FINAL MITIGATION PLAN

**Junes Branch
Jackson County, North Carolina
Project No. 95027**

IRT PROCESS SUMMARY

Re: NCIRT Review and USACE Approval of the Junes Branch Mitigation Plan (SAW 2012-01101)

SCALE: AS NOTED	DESIGN BY: cme	PROJECT NO.: 1049	DRAWING NUMBER: P-1
DATE: 12/12/2012	CHECK BY: SGG		
DATE:	BY:	REV:	DESCRIPTION:

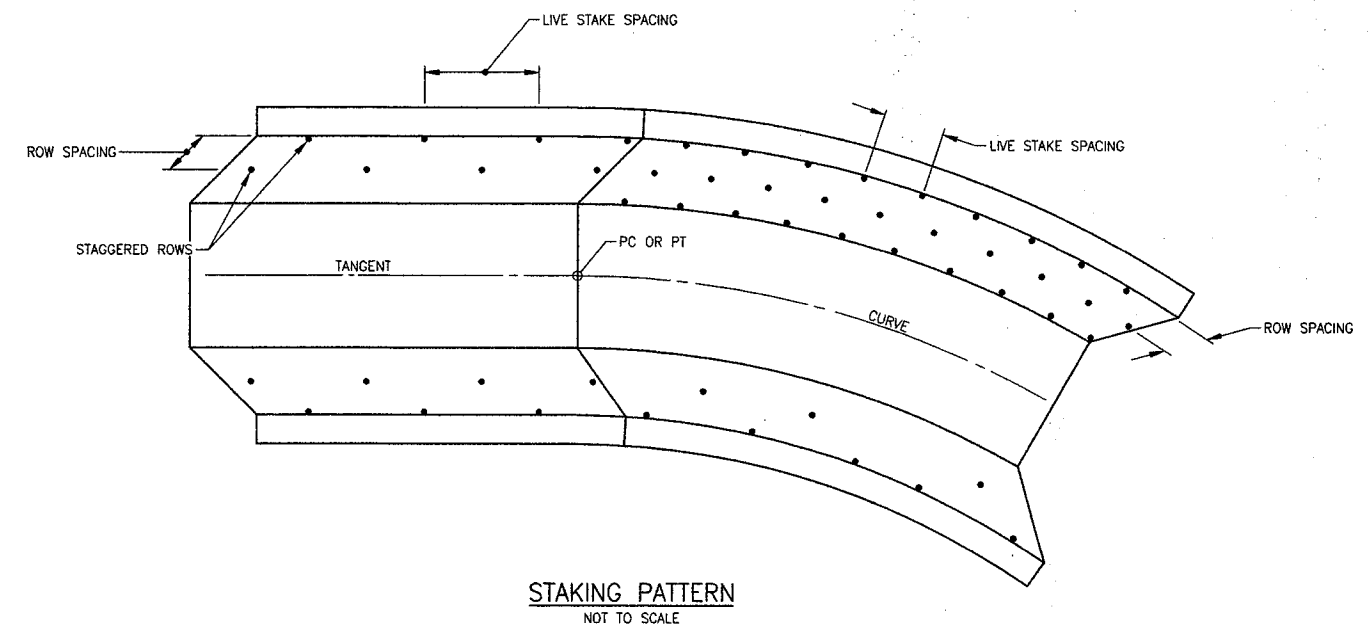
- The permanent seed mix consists of white clover, orchard grass, creeping red fescue, Korean lespedeza, and birdsfoot trefoil. All but red fescue are exotic and are not listed as noxious, but the USDA plants database says they all have the potential to become weedy or invasive. DWQ recommends using a native riparian seed mix, a number of which are available through native plant nurseries.

- I had a productive and interesting discussion with Grant Ginn regarding Bumgarner Branch. The design dimension for this reach is supported by the regional curves, and the proposed design is supported by DWQ. DWQ maintains the recommendation that the permanent seeding mix consist of native riparian species, and not the list proposed in the draft plan.

1. Revised permanent seed mix: Appendix D, Sheet P-1, Permanent Seeding Table
2. Revised Performance Standards:
 - Page 31, Paragraph 1, revised first sentence to reference USACE Stream Mitigation Guidelines (2003).
 - Page 31, Paragraph 2, Deleted reference to Entrenchment Ratio requirements.
 - Page 31, Paragraph 6, Added statement that bankfull events must happen during separate monitoring years.
3. Revised Doris Branch alignment to provide more than 30' buffer: Appendix D, Sheet 10.
4. Added statement that wetland areas will be protected by fence during construction: Page 26, Paragraph 6.
5. Revised background aerial image to remove barn that no longer exists:
 - Appendix D, Sheet 1A
 - Page 29, Figure 7
